## **Floyd Hill Design Technical Team Meeting Summary**

January 27, 2023, 9:00 AM to 12:00 PM

### 3. **Confirm: Central Section Alignment**

### 3. Discuss: Central Section Bridges

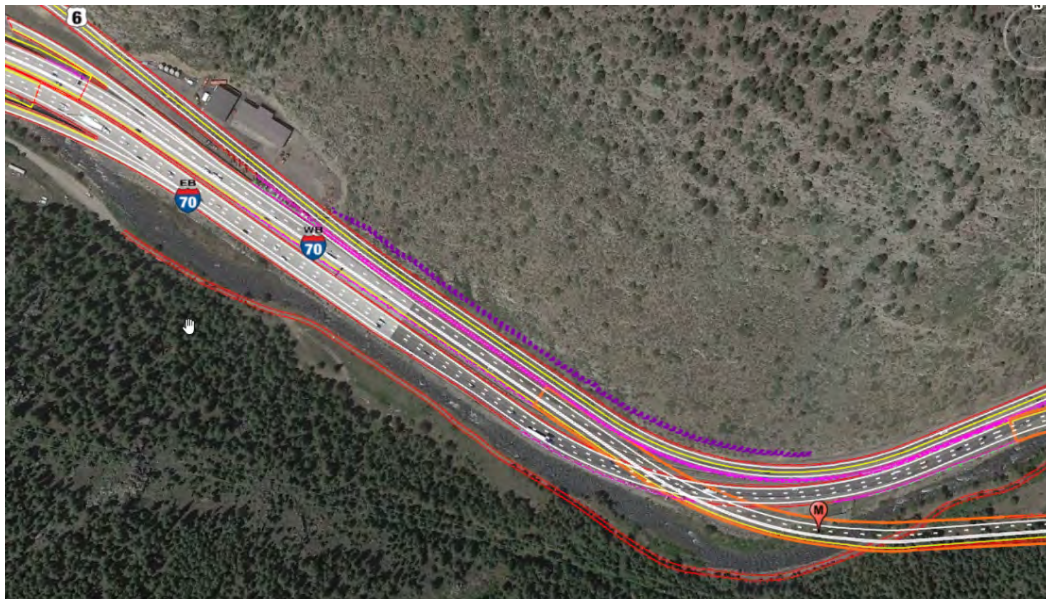
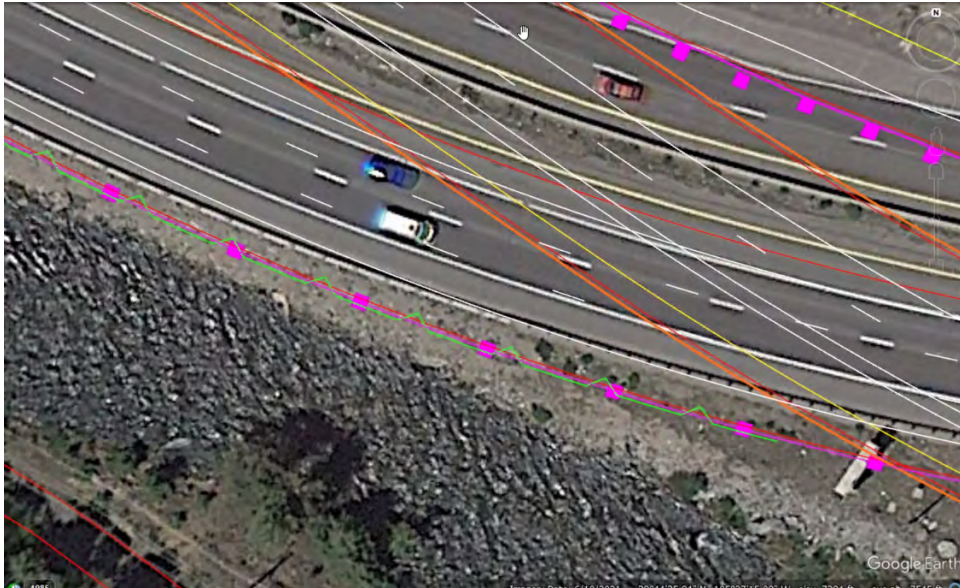
- **TT Question:** Where would the new alignment require a wall?
- **Response:** A short wall (~3 ft) would be required at the pinch point between the road and the creek. (Below: the pink and green lines represent the wall.)

- **TT Question:** how much of the North side would actually require rock cut?
- **Response:** Most of the section West of the curve will only require excavation of gravel and dirt. There will be rock cut at the curve but not as much as in the original PA '21. We will look at wall types as we gather geotechnical information.

- **Question:** What is the elevation of the greenway vs. roadway in this alignment?
- **Response:** The roadway will be above the greenway: WB will be lifted above the current elevation and EB will be similar to existing WB. This has benefits for reducing sound and improving the experience along the Greenway.

#### **Bridge A at US 6- Option 4: Spliced U Girders**

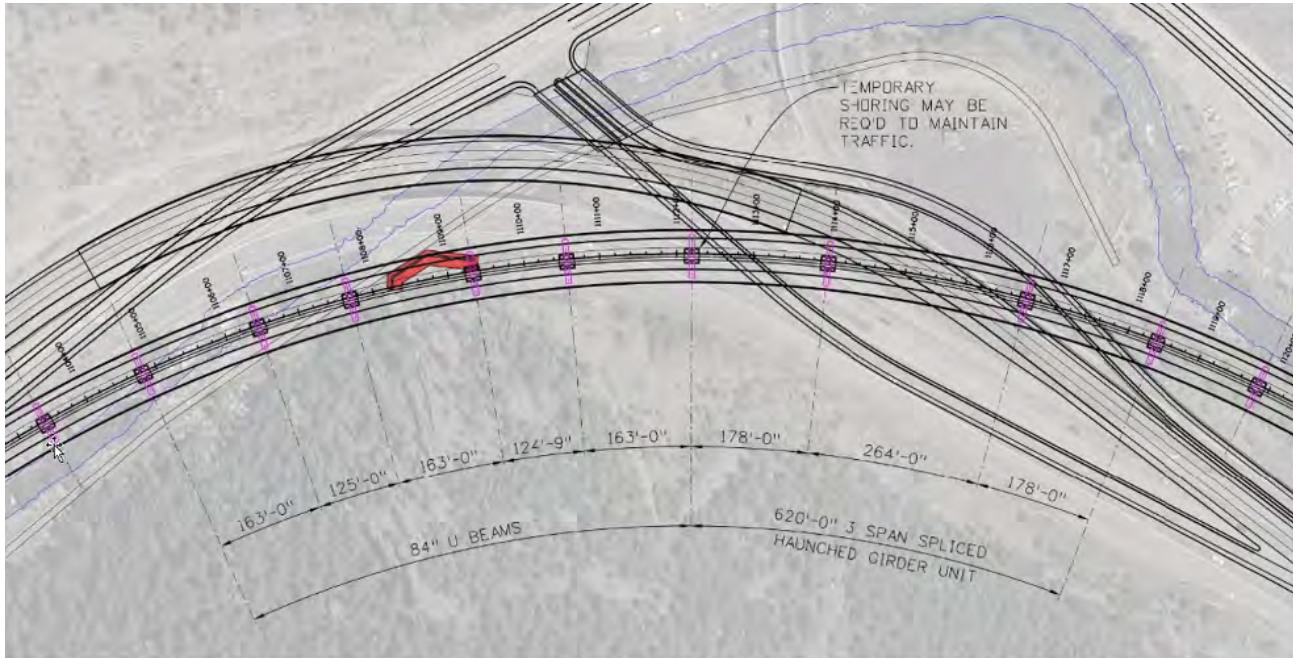
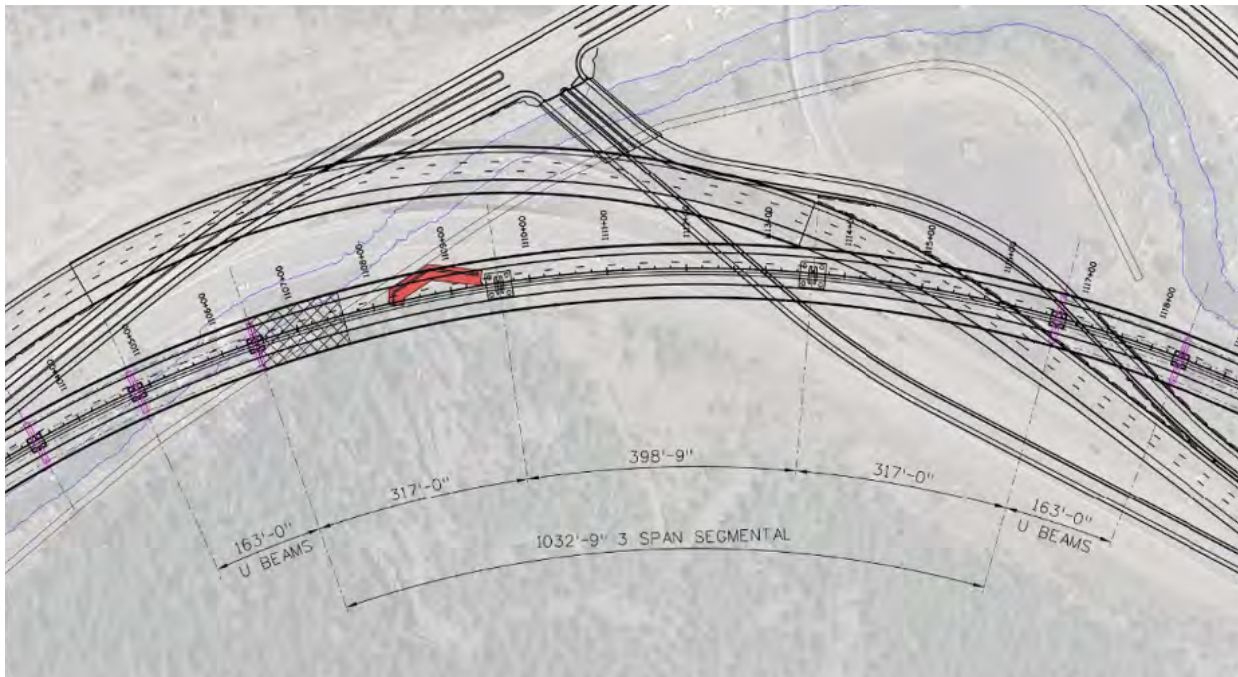
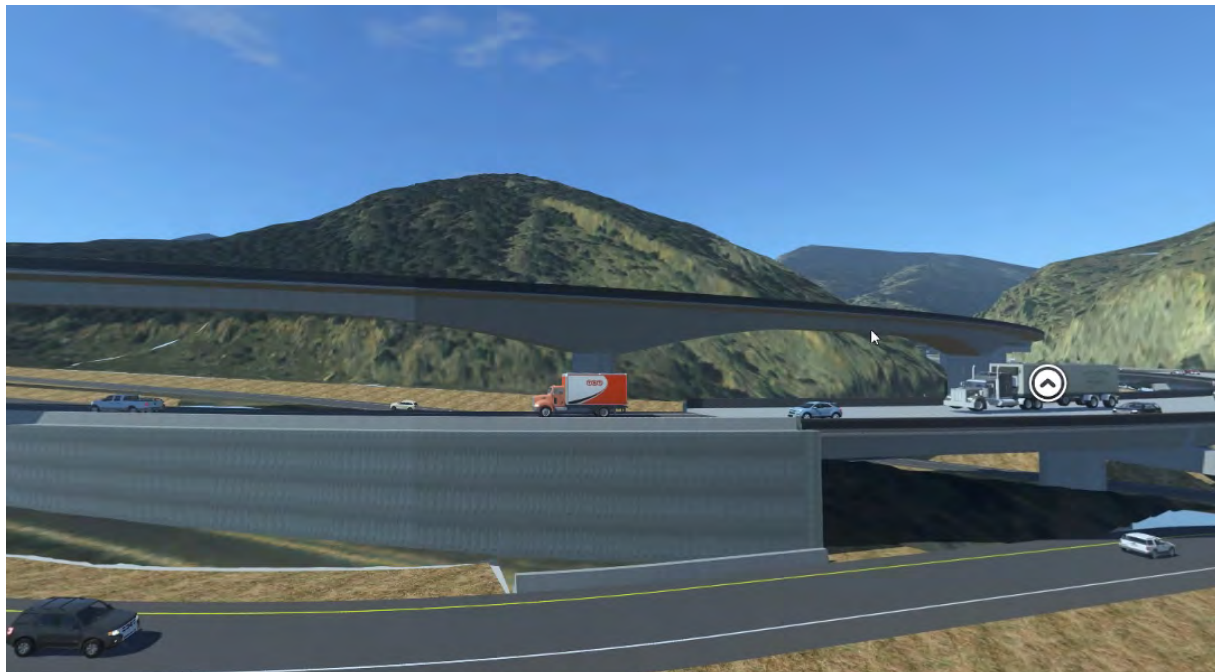
- **TT Question:** as the TT, would you like us to provide input on the aesthetic impacts of the alternatives?
- **Response:** Yes, as well as considering risks. We will look at renderings of both options in a moment to get a better sense of aesthetics.

- **TT Question:** What is the red shape in both maps?
- **Response:** Old buttress wall that we want to maintain in place.
- **TT Question:** Will there be any rock blasting in this area?

- **Response:** No.
- **TT Comment:** Option 5B, although less consistent with other bridges, is more adapted to landscape. There is not a major visual difference at this location because traffic is moving quickly and this bridge is blocked from view from the Greenway.

- **TT Question:** Is there a significant difference in constructability?
- **Response:** There is not a significant difference in schedule (1 month longer for 5B) but construction is quite different.

- **TT Question:** How long will temp towers be up?

- **Response:** 4-5 months.
- **TT Question:** Will the shoring towers be in the rockfall area?
- **Response:** No, they will be on the East section of the curve, the rock fall area is to the West of the curve.
- **Question:** Can you describe nighttime closures and why that applies to Option 4 but not Option 5?
- **Response:** The temporary supports require bringing in concrete pieces with cranes, which require road closures. Those closures would be at night and a detour would send traffic to US 6. The team believes that Option 5B, segmental bridge construction, will not require road closures. It will require more deliveries which may increase congestion.

- **TT Question:** Are there any maintenance differences/challenges over time?
- **Response:** Option 5B is more resilient over time- it incorporates fewer expansion devices, which can be prone to leaking, and need to be replaced every 10-20 years.
- **TT Comment:** As the TT, we do not have the technical expertise to make this decision. As far as we have discussed, neither option has an outsized effect on the aesthetic impact to the area, so this decision belongs to the professionals.

**TT Agreement:** Through consideration of the materials presented today, Option 4 or 5B do not have significant aesthetic impacts to the area. This decision should be made by the technical professionals on the Project Team.

**Comparison of Option 1: Spliced U Girders (Above) and Bottom: Segmental Bridge (Below)**

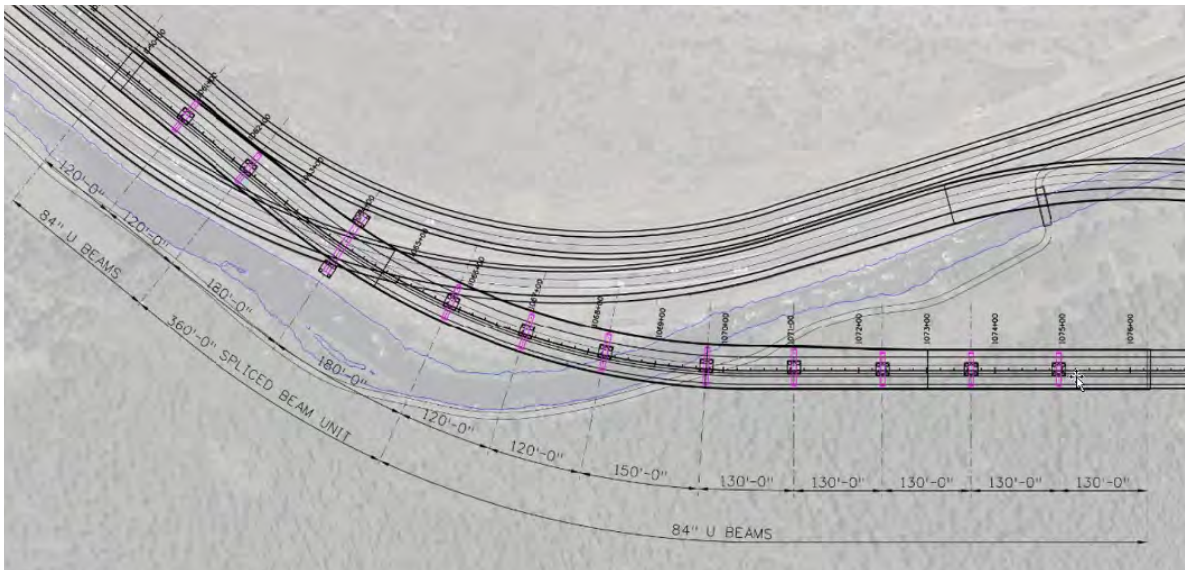
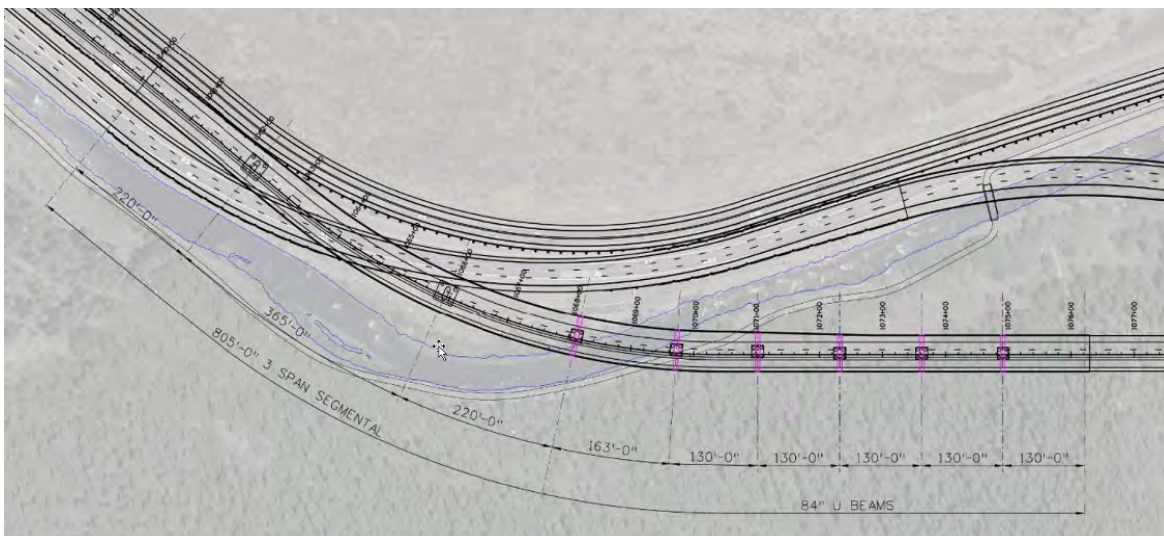
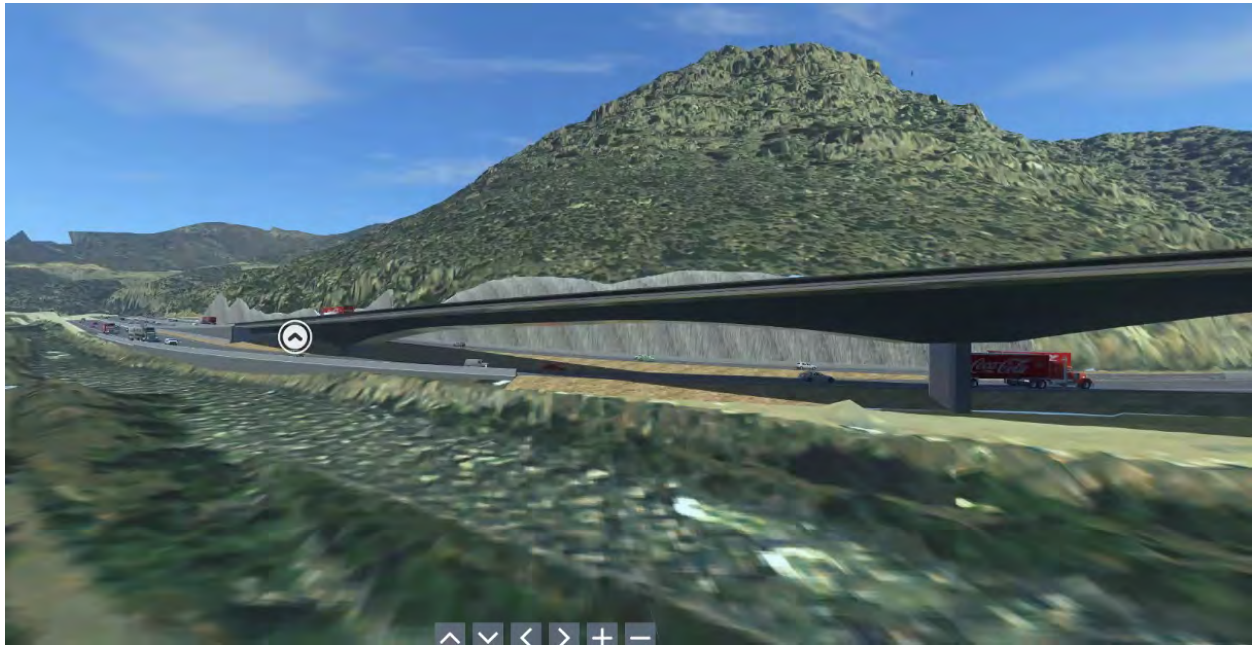
- **TT Comment:** At this location, the visual difference is somewhat more pronounced. The Segmental bridge blocks more visually due to deeper concrete over the piers. The Spliced U Girder bridge appears more open.

**TT Agreement:** There is some visual preference for the Spliced U Girder bridge option, however, the TT will leave the final decision to the technical experts.
